**UNC Charlotte Union Parking Deck Expansion**  
**SKA Project No. 160367.1**  
**SCO ID No. 16-15657-02A**  
**March 16, 2017**

**Subject: Addendum #02**

**1**  
**S2.4** LEVEL 5 FRAMING PLAN  
3/32" = 1'-0"

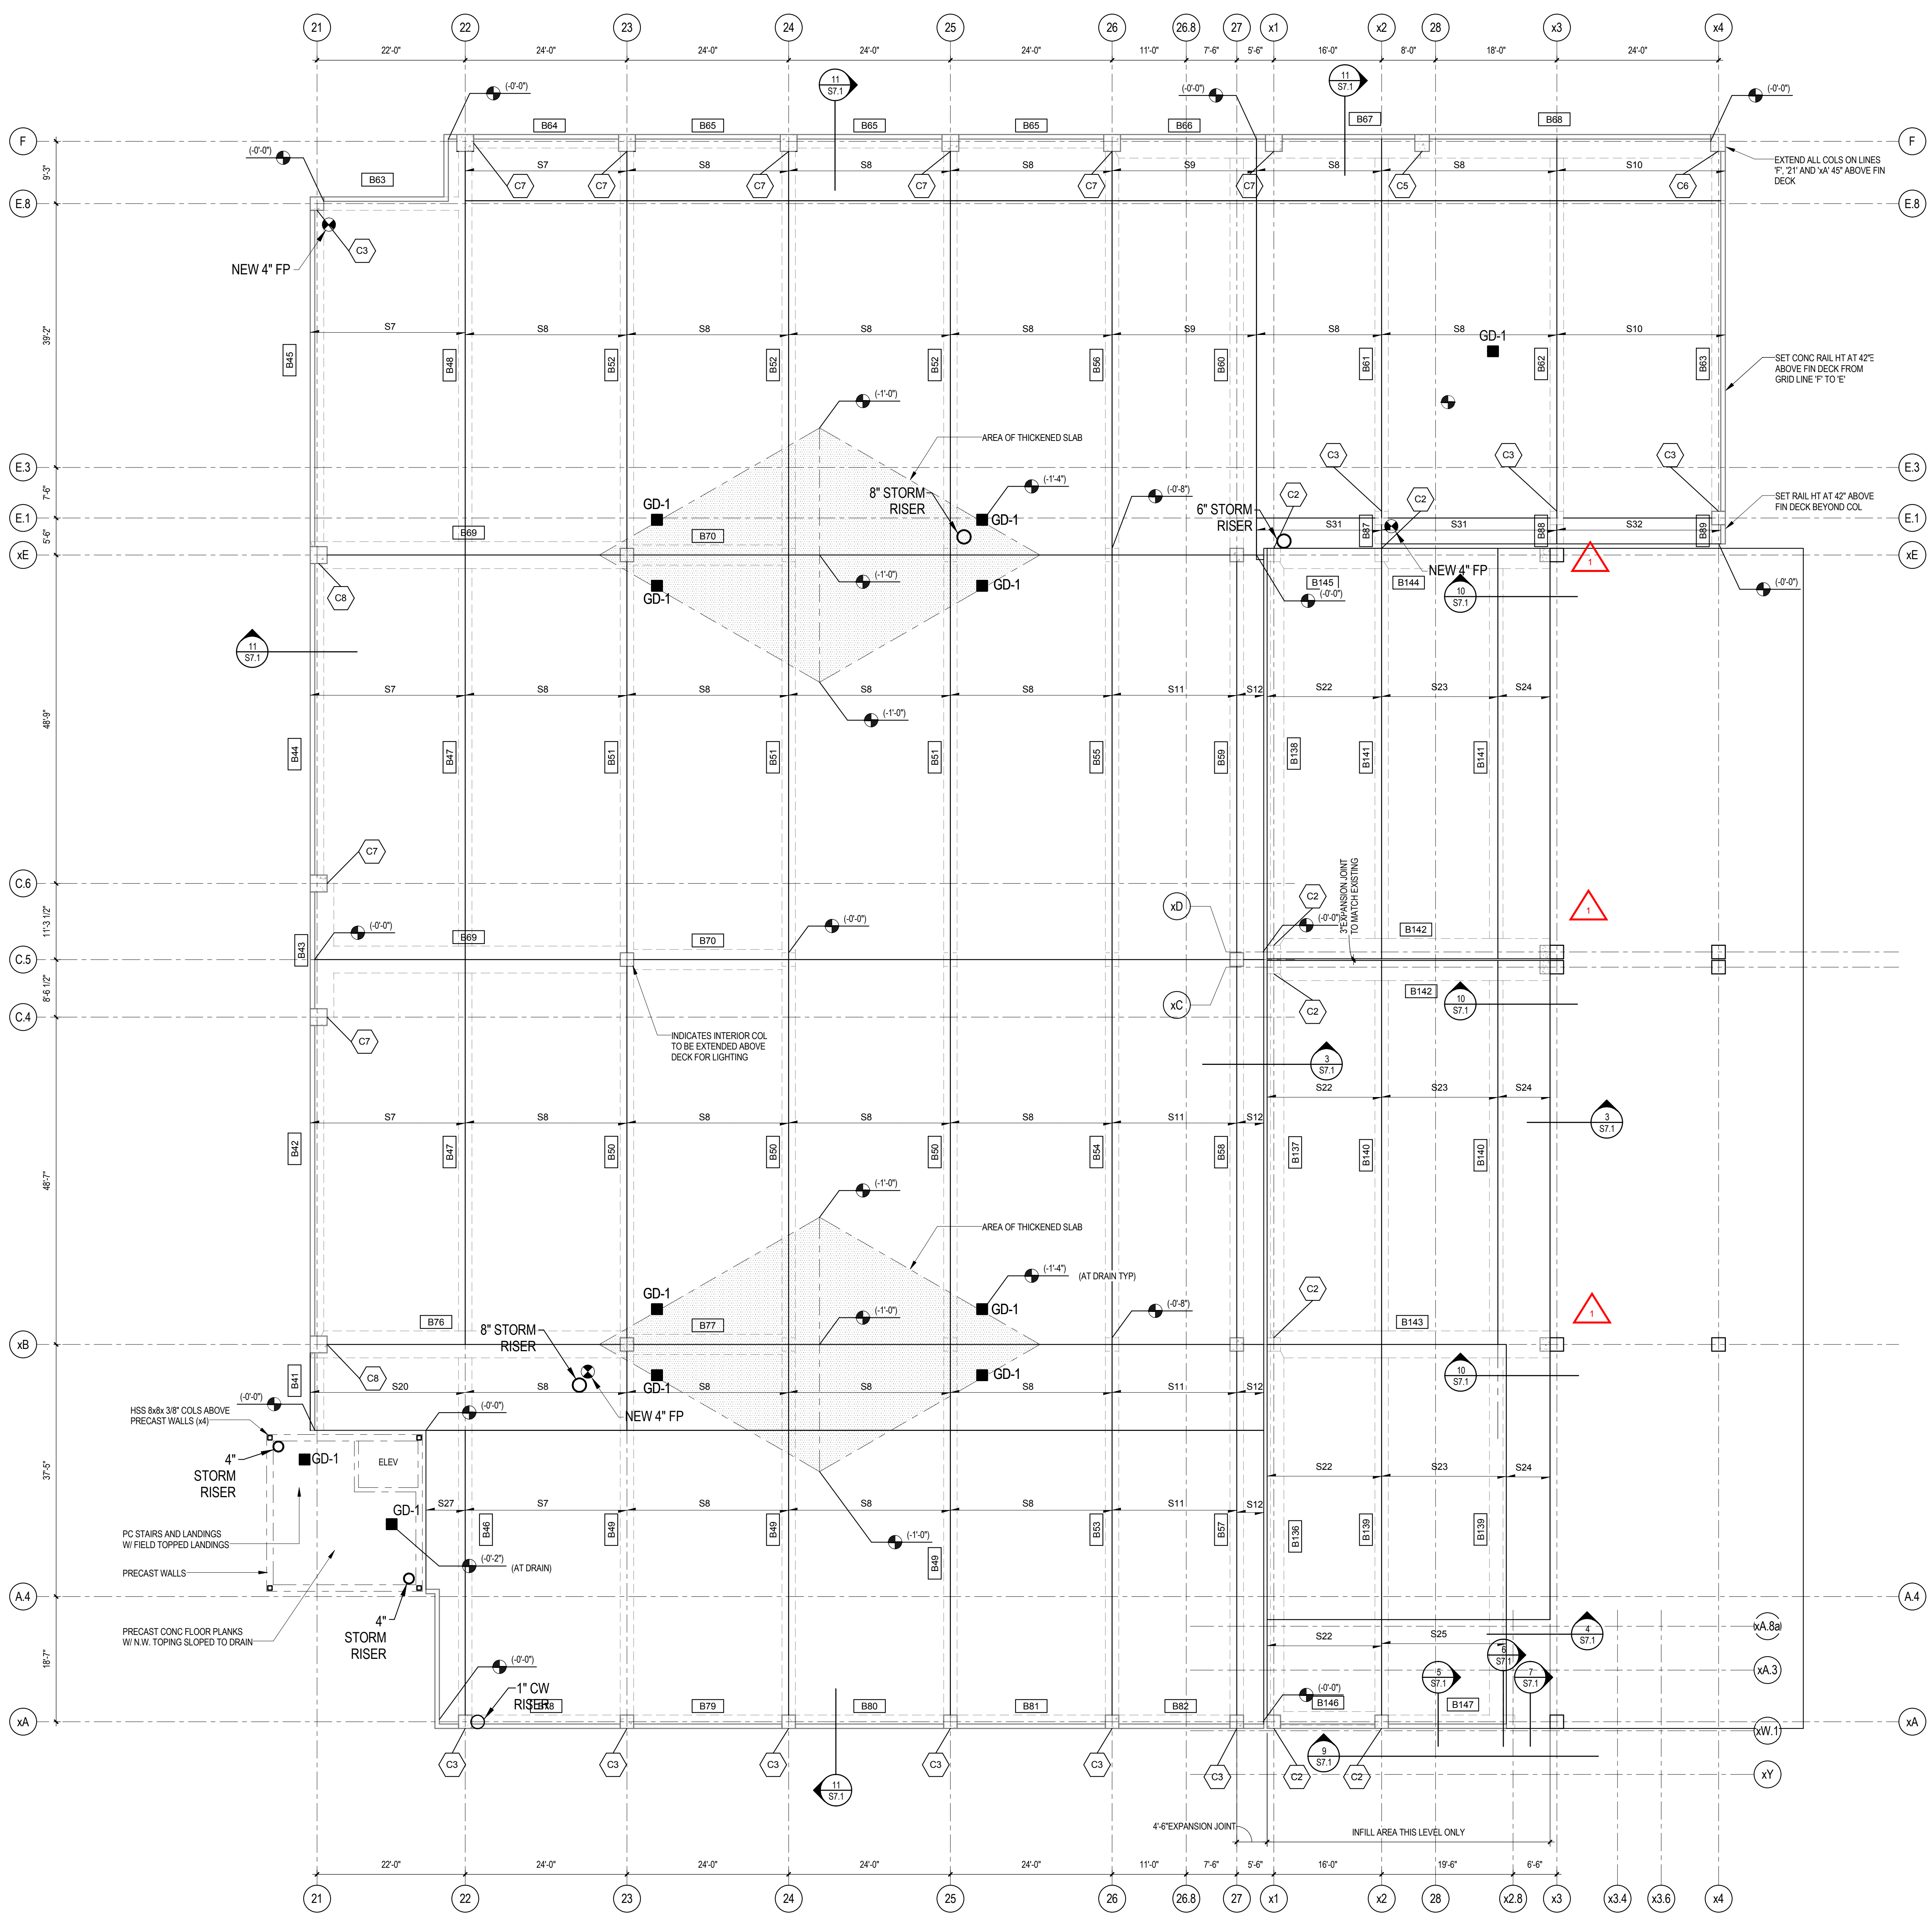
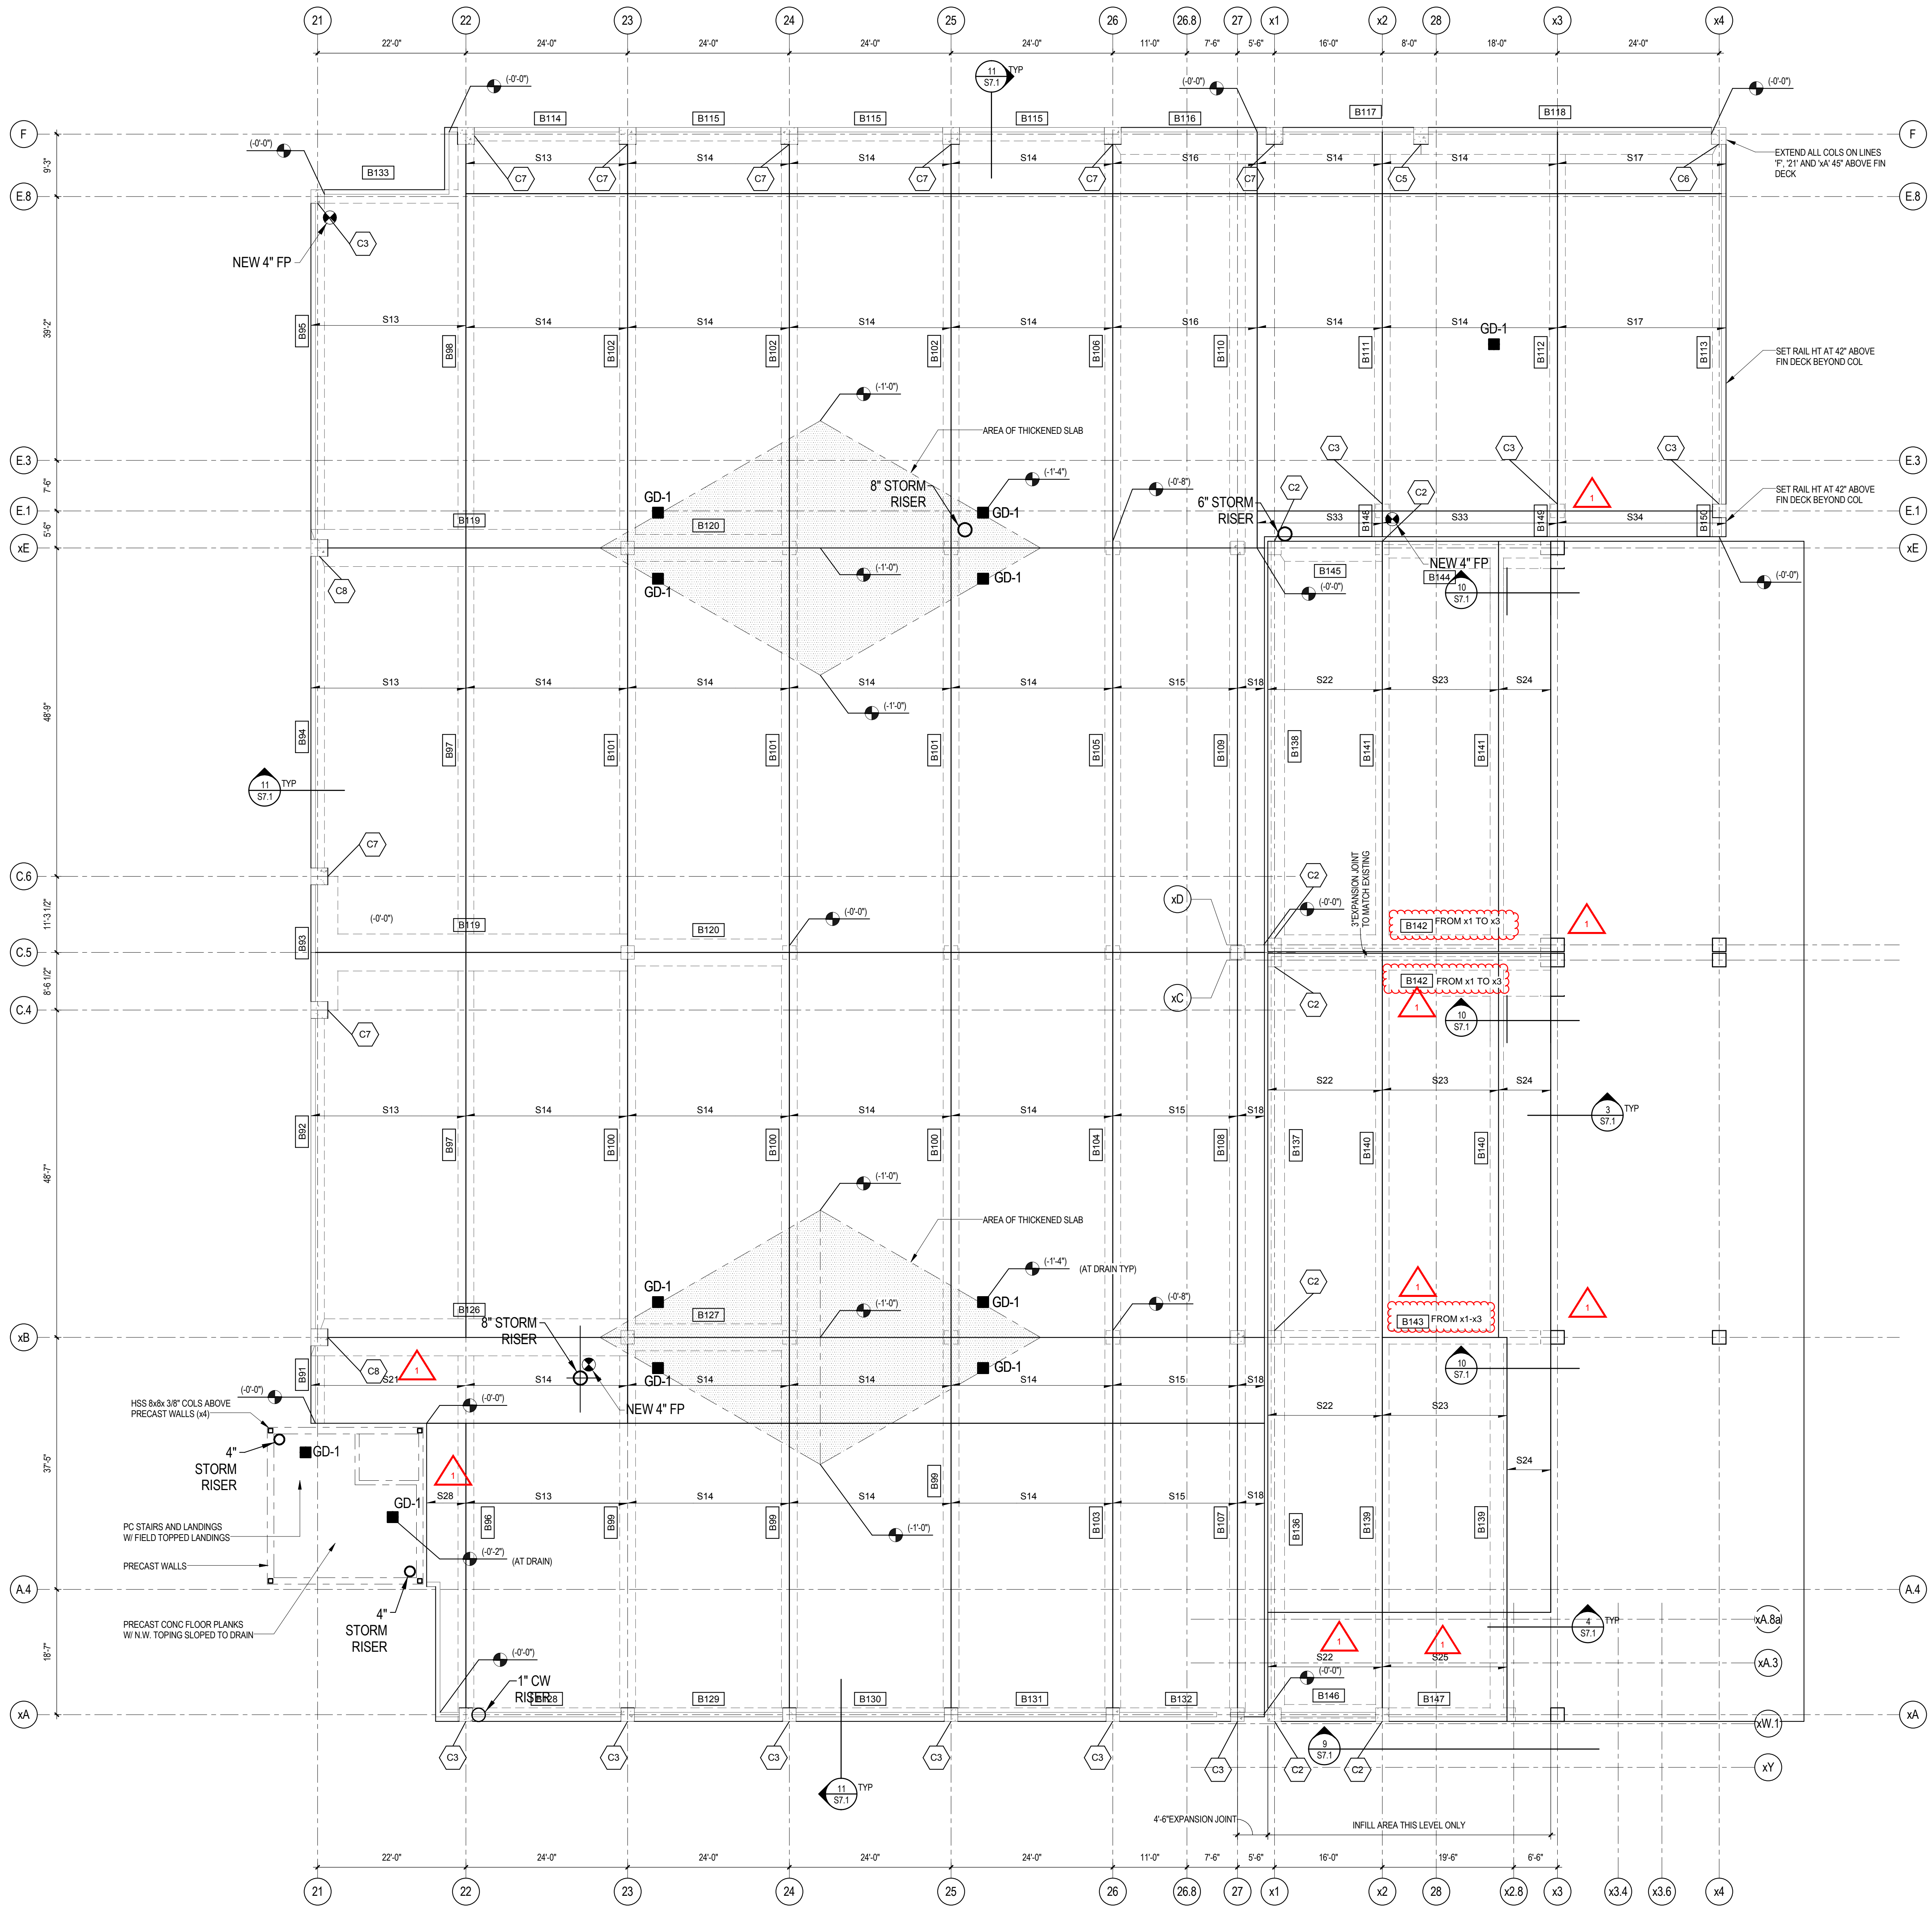
SECTION CUTS FOR EXPANSION JOINTS APPLY TO ALL SUSPENDED FLOORS

REMOVE EXISTING BARRIER CABLES AND REANCHOR AT LINE X1. TYP ALL LEVELS FOR DRIVE AROUND ACCESS.

CONTRACTOR SHALL CHIP AND REMOVE EXISTING CONCRETE FOR RECESSING OF EJ W/ING ALL LEVELS.
